**GULF STATES UTILITIES COMPANY**

River Bend Station Unit 1  
Docket No. 50-458

This letter is Gulf States Utilities (GSU) response to your October 17, 1984 request for additional information concerning River Bend Station shear reinforcement design. Please find enclosed forty (40) copies of GSU's response to items 1 through 4. These responses were discussed with your Mr. H. Polk on October 23, 1984. If you have any additional questions please contact us.

RESPONSE TO QUESTIONS RAISED BY THE NRC  
ON REACTOR SHIELD BUILDING SHEAR REINFORCEMENT

ASSUMED SHEAR REINFORCEMENT

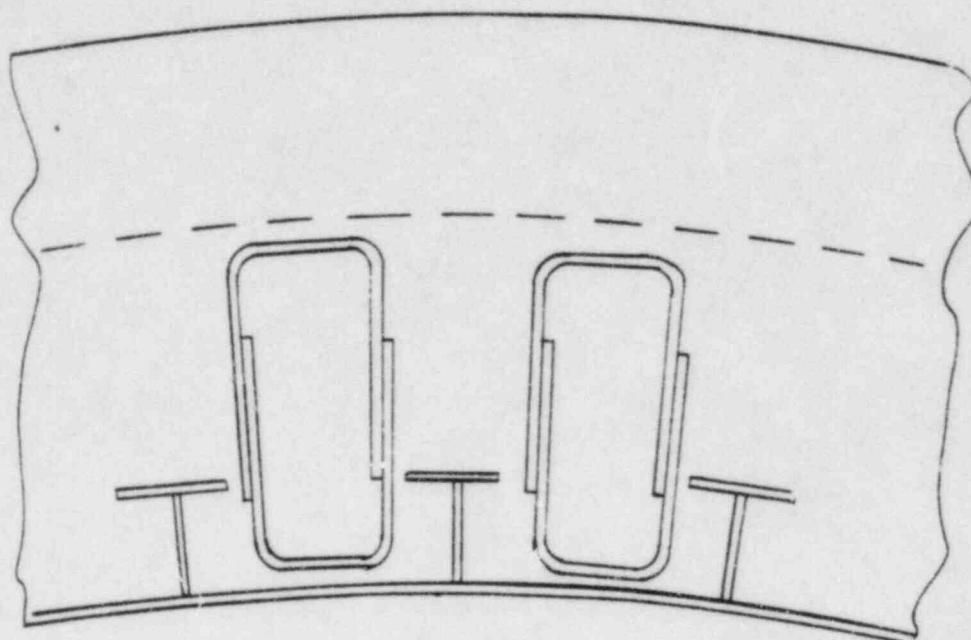
TRY:

#8's @ 6" c/c VERTICALLY EL 40' TO EL 74'  
# 6's @ 12" c/c " EL 74' TO EL 80'

GRADE 40 BARS

32       $\therefore$  SHEAR REINFORCING AS PROPOSED  
 33      ON Pg 304 IS O.K.
